Ladder Diagrams for Error Recovery For FCP -2 Rev 04 Out-Of-Order Delivery- Annex D

T10/00-137r5

Reference: T11/00-133r1, r2, r3 and r4

Summary of Changes

D.5 Class 3 FCP_RESP Lost, No FCP_CONF Req.

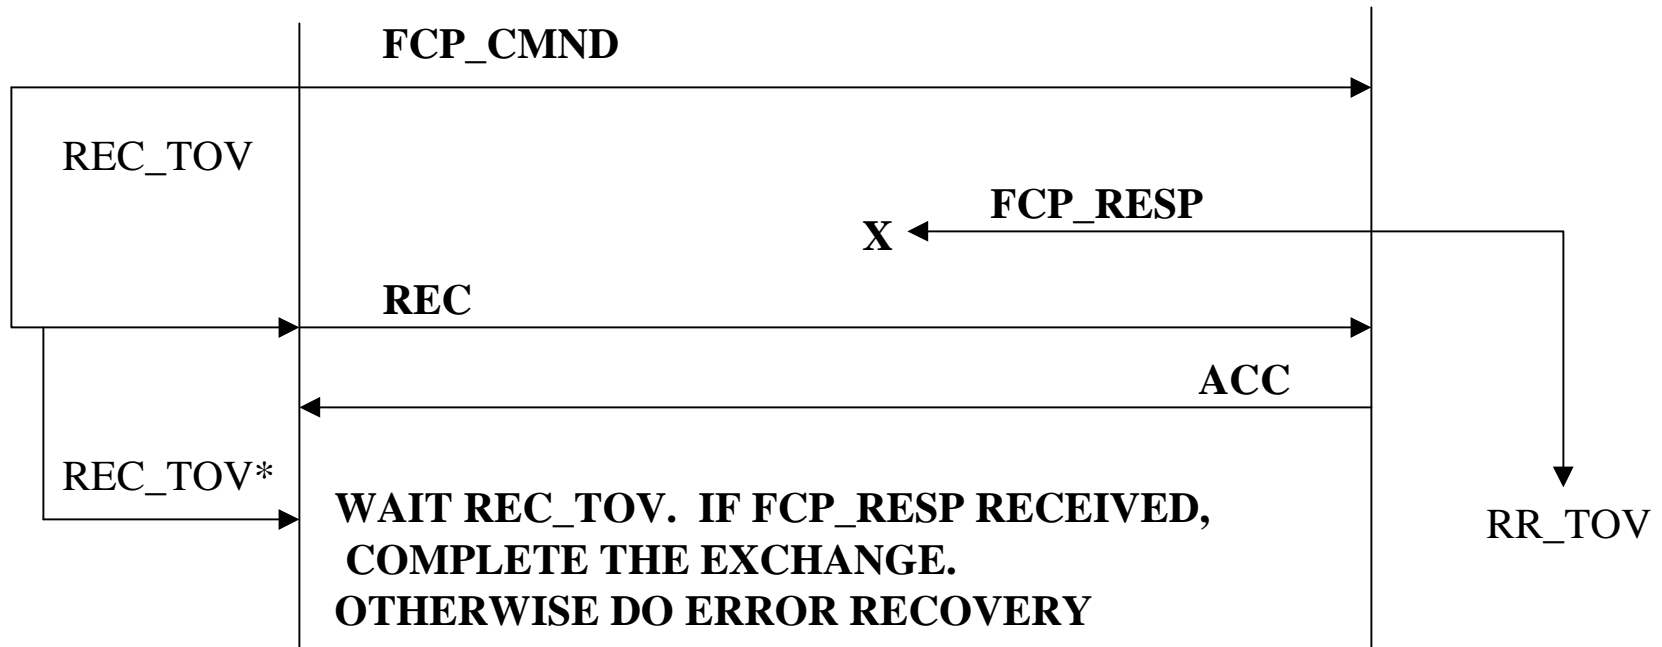
For Exchange level recovery, the context of the Exchange can be purged by the Target after FCP_RESP is transmitted.
Incorporate the above in the text

D.13 C1 3, REC Lost

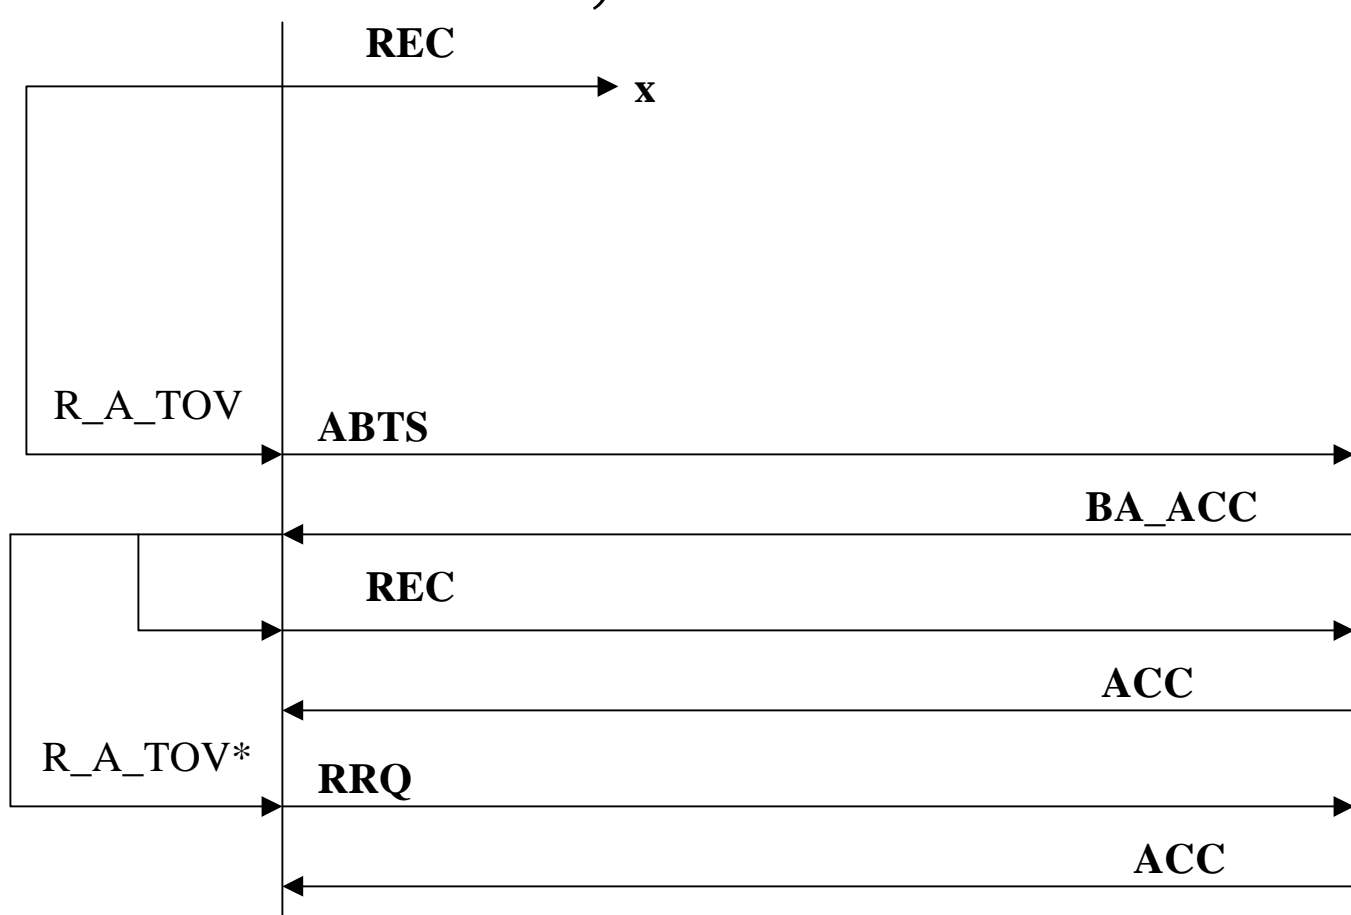
Since the REC was never received by the Target, the BA_ACC payload is SEQ_ID invalid, low SEQ_CNT =0, high SEQ_CNT= SEQ_CNT of ABTS=1. Recovery qualifiers are established on both sides. The second REC must be issued in a new Exchange. For in-order delivery the value of R_A_TOV* is 0. Change E_D_TOV in the text to R_A_TOV in 12.6.2

D.13a C1 3, REC Response Lost

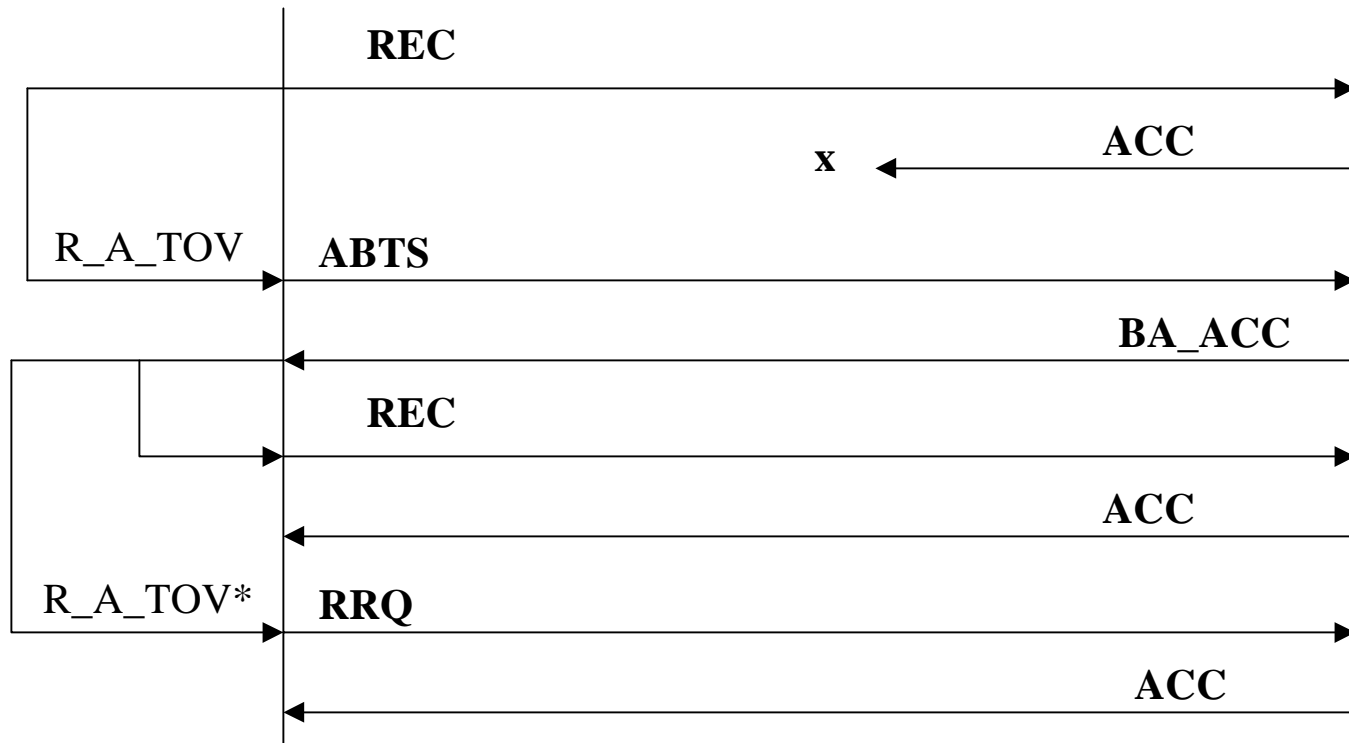
Change E_D_TOV in the text to R_A_TOV in 12.6.2

D.13? C1 3, Two RECs Lost, Abort the original Exchange

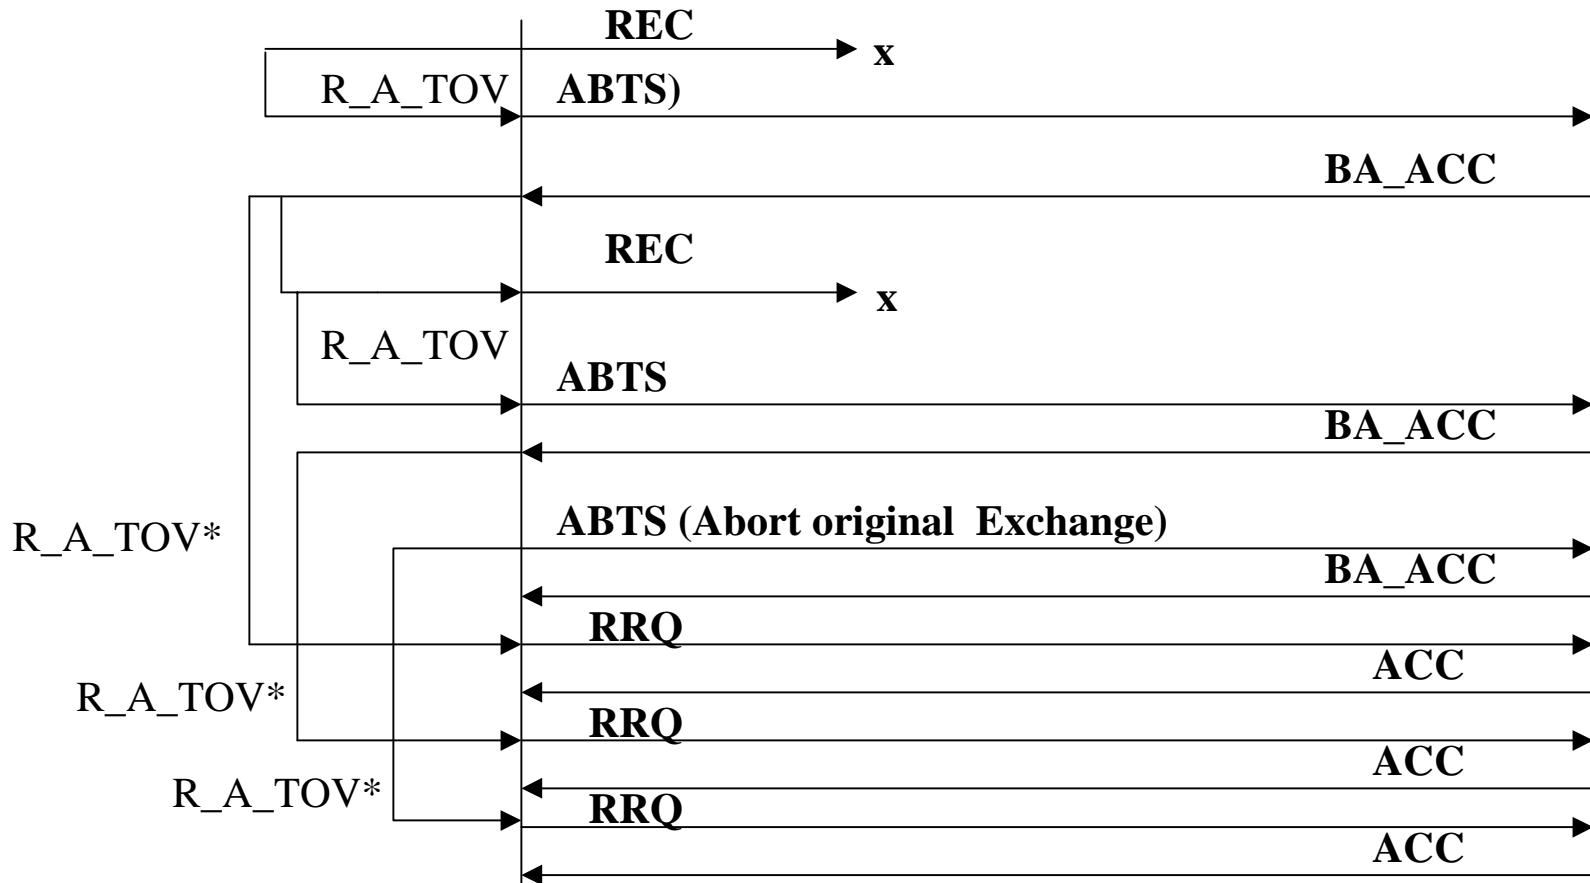
Recovery Qualifiers are established on both sides for each Exchange. For in-order delivery, the value of R_A_TOV* = 0. (In the text 12.6.2. add sentence specifying that if two RECs fail, the original Exchange is aborted, regardless of Class.)

(Out of context: Need to put somewhere in the text, that any ABTS or RRQ failure causes the Exchange to be aborted.)

D.14a Class 3, SRR Lost, Abort the Original Exchange

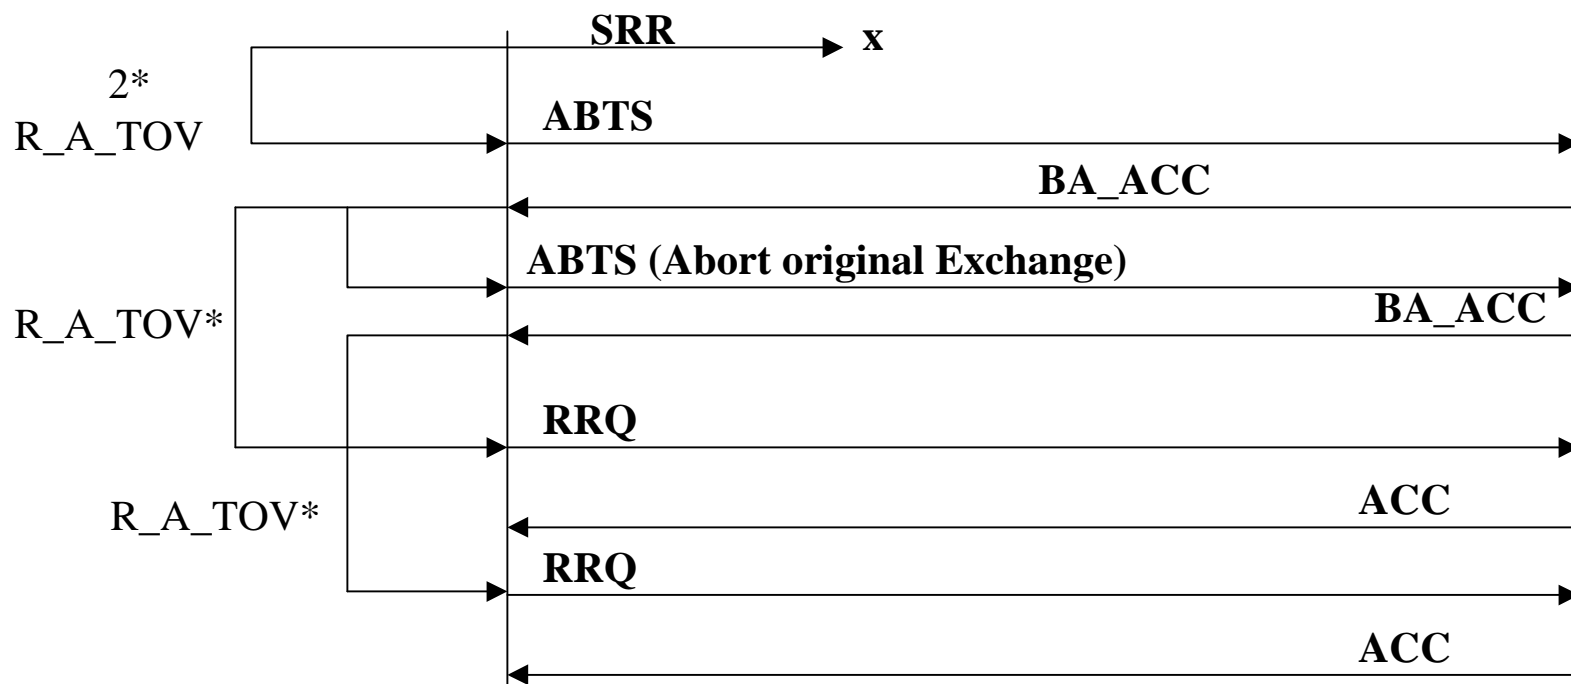
*(In the text in 12.6.3, add a note that for Class 3 that an SRR failure causes the original Exchange to be aborted. In Class 2, 2 failures of SRR cause the original Exchange to be aborted Change E_D_TOV in the text to $2 * R_A_TOV$ to agree with the text in 12.6.3)*

D.14b Class 3, SRR Response Lost

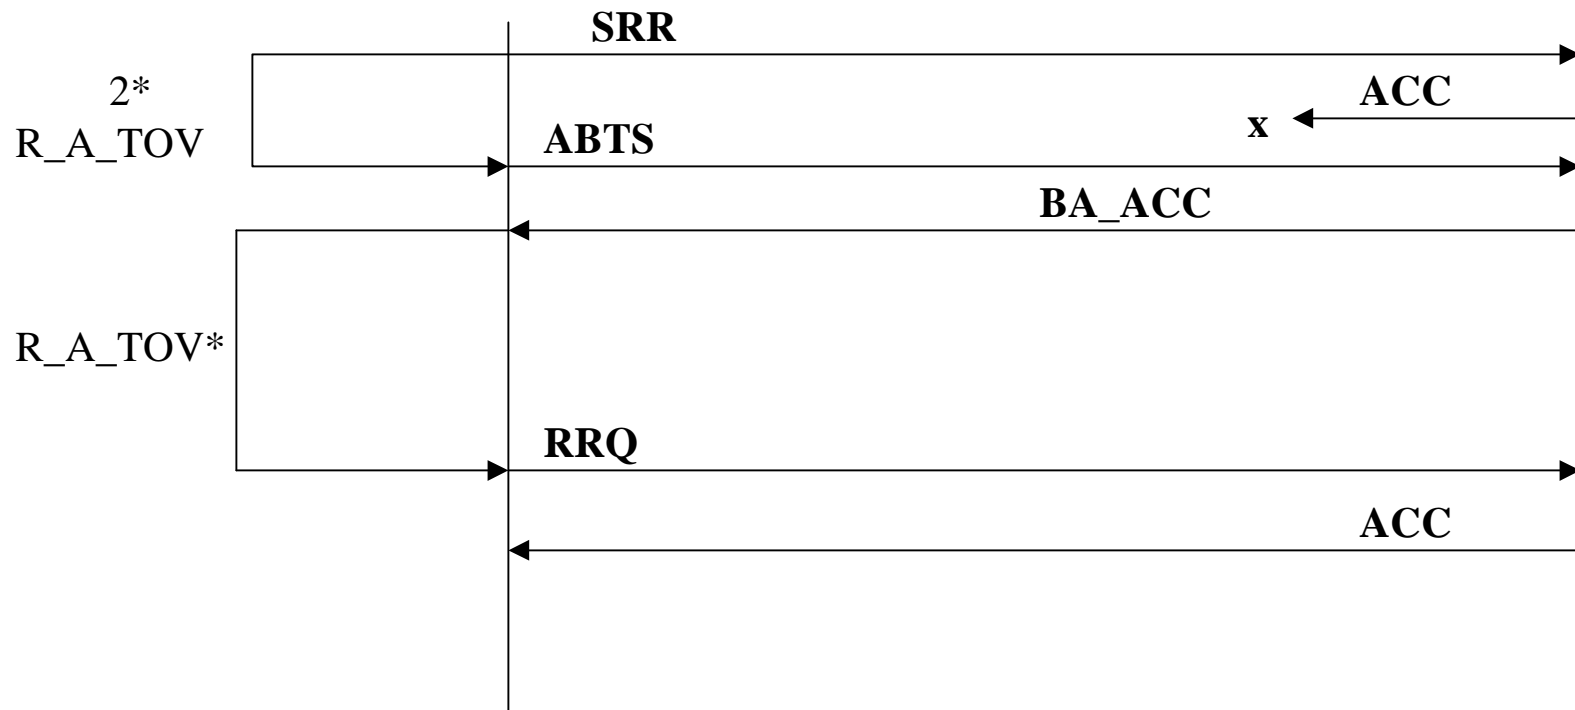
{Note out of context: If the response to SRR is LS_RJT, then the original Exchange shall be aborted or treated as if it had been aborted by the Exchange Initiator, if it is still active--add to 8.3text, hard copy page 33.}
